Model: Adonis-C2 PT1045		Date: 14-Sep-01	No.: MB376001
Modified Article: Left Guide Plate - Middle		Prepared by: E. Fukuyama	
From: Technical Services Dept., GTS Division			
Reason for Modification:	<input type="checkbox"/> Parts catalog correction <input type="checkbox"/> To facilitate assembly <input type="checkbox"/> Part standardization	<input type="checkbox"/> Vendor change <input checked="" type="checkbox"/> To improve reliability <input type="checkbox"/> Other	<input type="checkbox"/> To meet standards (      )

Model: Adonis-C2 PT1045		Date: 20-Mar-02	No.: MB376002
Modified Article: Upper Right Cover and Mylar		Prepared by: E. Fukuyama	
From: Technical Services Dept., GTS Division			
Reason for Modification:	<input type="checkbox"/> Parts catalog correction	<input type="checkbox"/> Vendor change	<input type="checkbox"/> To meet standards ( )
	<input type="checkbox"/> To facilitate assembly	<input checked="" type="checkbox"/> To improve reliability	
	<input type="checkbox"/> Part standardization	<input type="checkbox"/> Other

Model: Adonics-C2 1bin Tray (PT1045)		Date: 25-Jul-02	No.: MB376003
Modified Article: Chromium Free		Prepared by: K. Takagi	
From: Technical Services

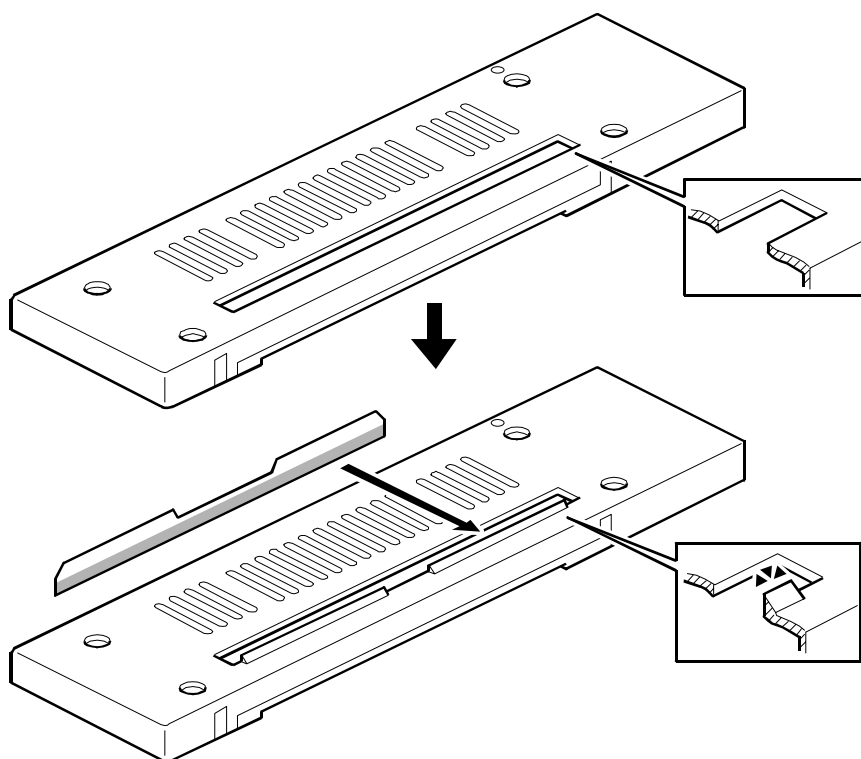
To further ensure that the Middle Left Guide Plate stays securely attached, the width of the boss has been increased from 6 mm to 9 mm.

Old part number	New part number	Description	Q'ty	Int	Page	Index	Note
A6842211	B3762211	Left Guide Plate - Middle	1-1	X/O	5	20
